SUBMITTAL SUMMARY REPORT
32788

PLAN NAME:	MIDWAY TERRACE	LOCATION:	7191 MIDWAY TER ALL UNITS OCALA,
APPLICATION DATE:	04/23/2025	PARCEL:	9007-0101-32
DESCRIPTION:	THE ONLY CHANGES TO THE APPROVED PLAN ARE THE RELOCATION OF THE DRAINAGE RETENTION AREA, A SMALL AMOUNT OF ADDITIONAL IMPERVIOUS PAVEMENT AREA, MINOR GRADING REVISIONS, AND THE UPDATED PIPE CONVEYANCE IMPROVEMENTS TO THE PROPOSED DRAINAGE RETENTION AREA. THE APPROVED LANDSCAPE BUFFER AND ALL OTHER IMPROVEMENTS WILL REMAIN AS PERMITTED.

IRRIGATION PLAN
MIDWAY OAKS APARTMENTS
MARION COUNTY FLORIDA

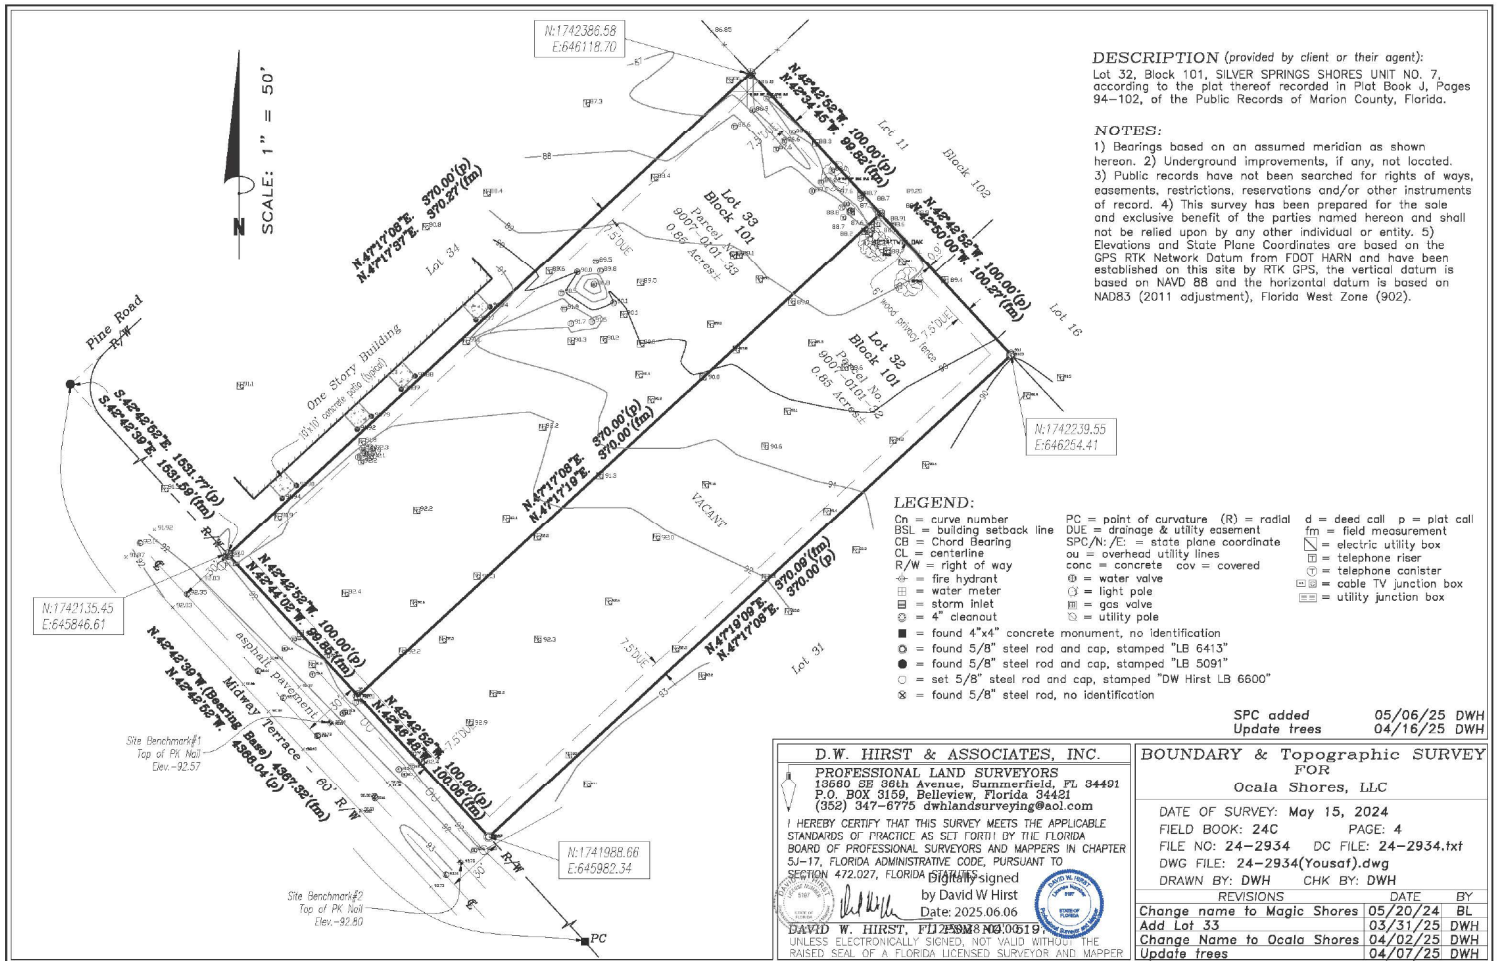
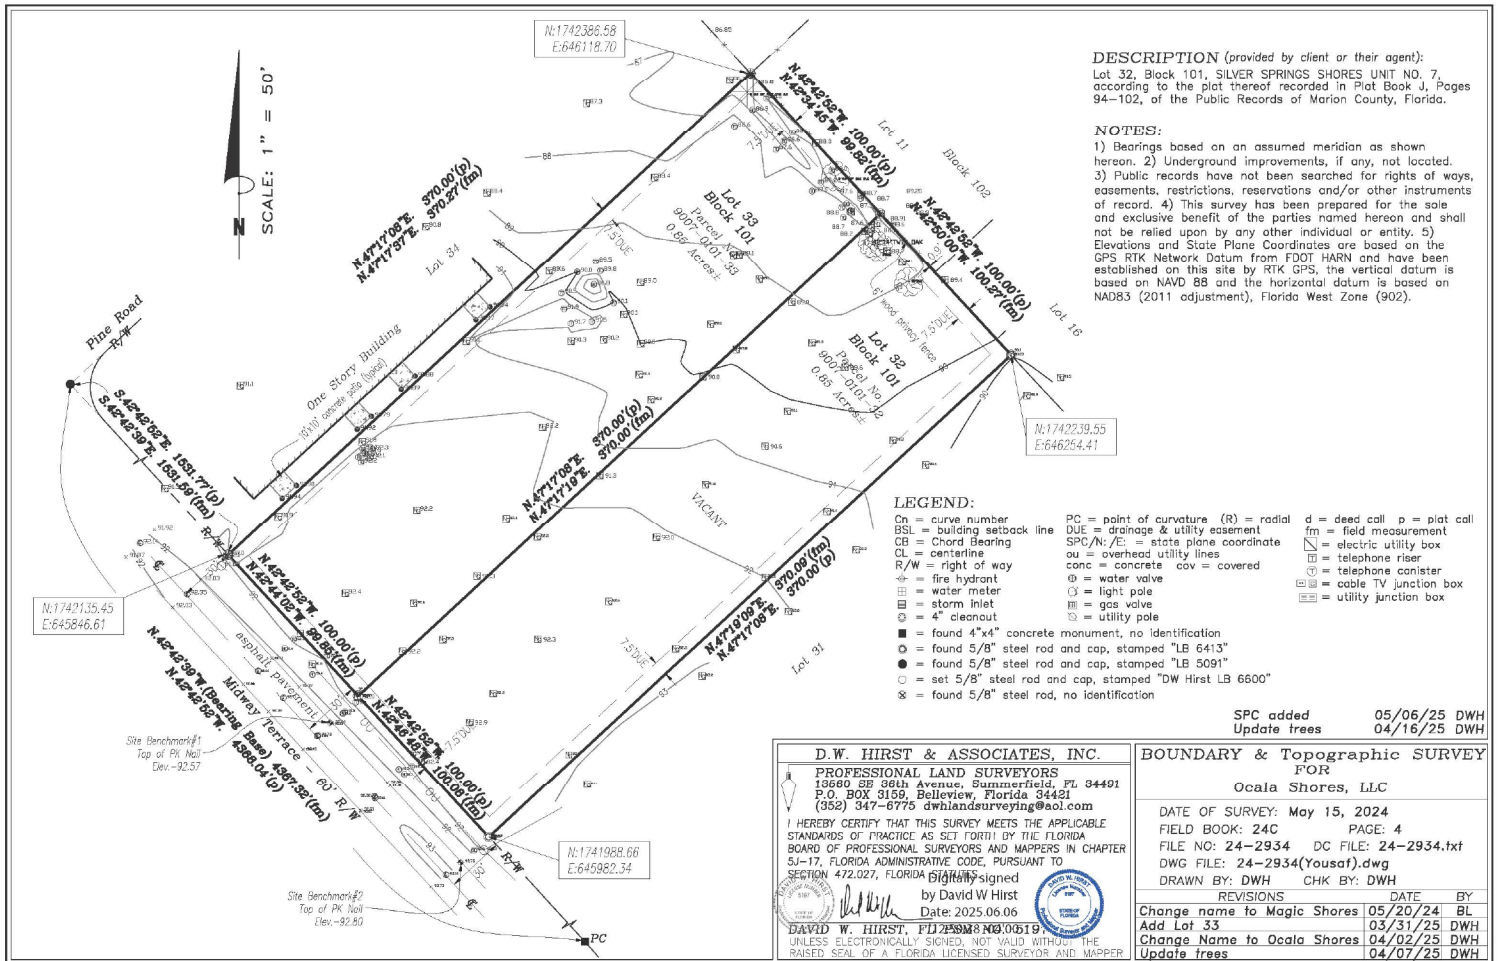
REVIEWER	MARKUP	DATE/TIME	FILE NAME	PG #
Susan Heyen	Provide planting per LDC 6.19.3.D.4	07/06/2026 10:25	AMMIDWAY OAKS FULL SET.pdf	8
